REMARKS

Appl. No. 10/075/067
Amendment B
Reply to Office Action mailed July 13, 2005

Amendments to the Drawings:

FIG. 5

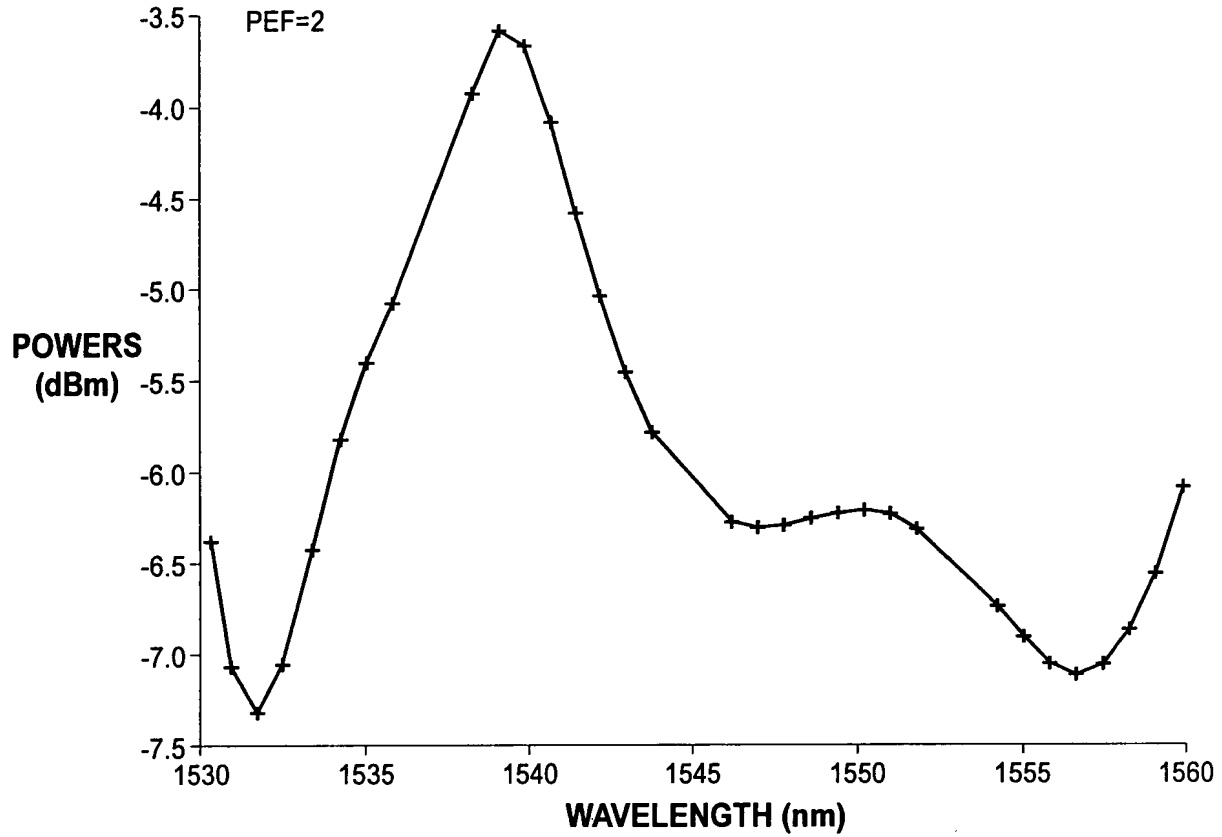
Also submitted herewith is a replacement sheet of drawing with the vertical axis of Figure 5 relabeled in accordance with the Examiner's requirements. A copy marked in red is also attached. It is believed that the previously submitted replacement sheet which included Fig. 1 as well as the presently submitted replacement sheet which includes Fig. 5 address the outstanding drawing objection.

The attached sheet of drawings includes changes to Fig. 5. This sheet, which includes Figs. 4-5, replaces the original sheet including Figs. 4-5.
